UNITED STATES PATENT AND TRADEMARK OFFICE

| APPLICATION NO. | FILING DATE | FIRST NAMED INVENTOR | ATTORNEY DOCKET NO. | CONFIRMATION NO. |
|-----------------|-------------|----------------------|---------------------|------------------|
| 09/909,557      | 07/20/2001  | Jean M. Beaupre      | END-778             | 8228             |

## Office Action Summary

## DETAILED ACTION

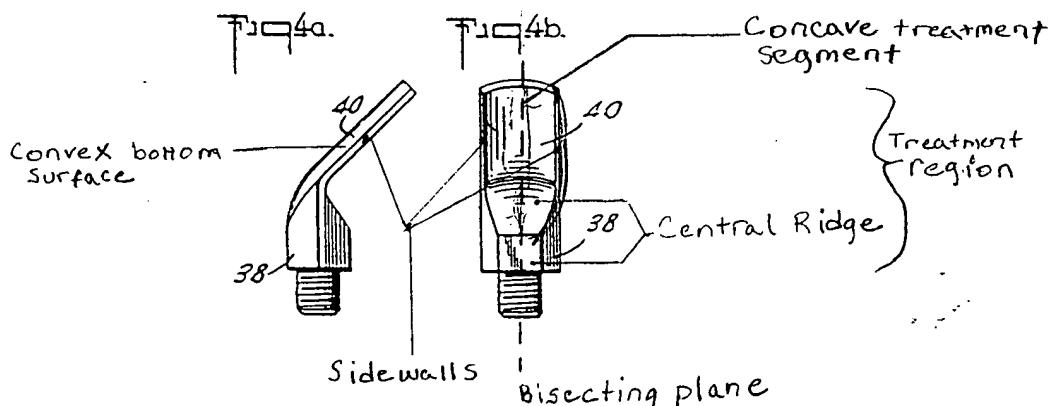
Claims 21, 22, 30 and 31 are rejected under 35 U.S.C. 102(b) as being anticipated by Balamuth et al. (US 2,990,616). Balamuth discloses an ultrasonic cutting tool (Figs. 4a-4b) comprising a concave treatment segment 40, first and second side walls, central ridge, and a convex bottom surface. The bisecting plane is longitudinally parallel with the instrument of Fig. 4a and is perpendicular to the paper. See figure below.

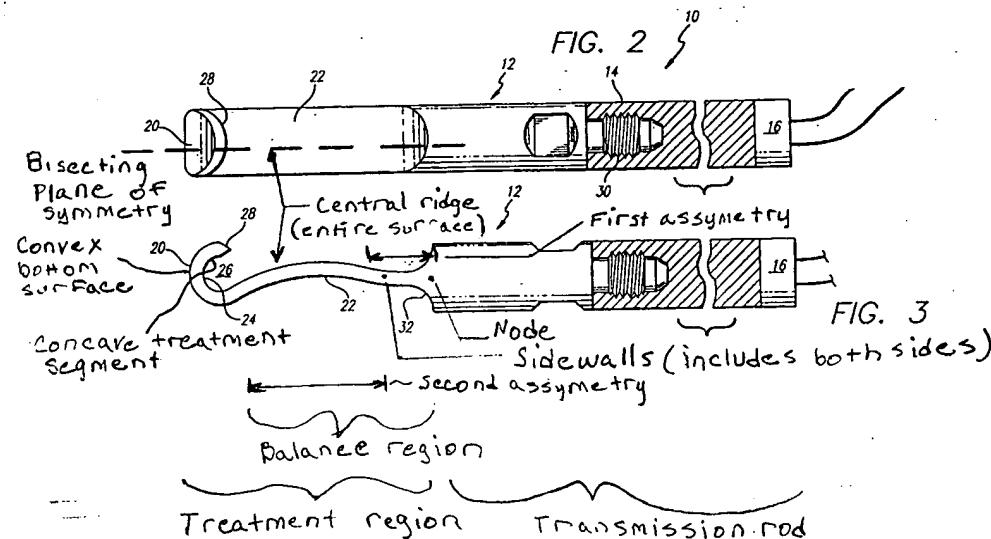
Claims 21-24, 28-30, 32 and 34 are rejected under 35 U.S.C. 102(e) as being anticipated by Hood (US 5,669,922). Hood discloses an ultrasonically driven blade (Figs. 2-3) comprising a concave treatment segment comprising first and second side walls, a central ridge, and a convex bottom surface. The bisecting plane is longitudinally parallel with the instrument of Fig. 2 and is perpendicular to the paper. It is inherent in the general shape of the ultrasonic blade that it will counter at least some torque. See figure below.
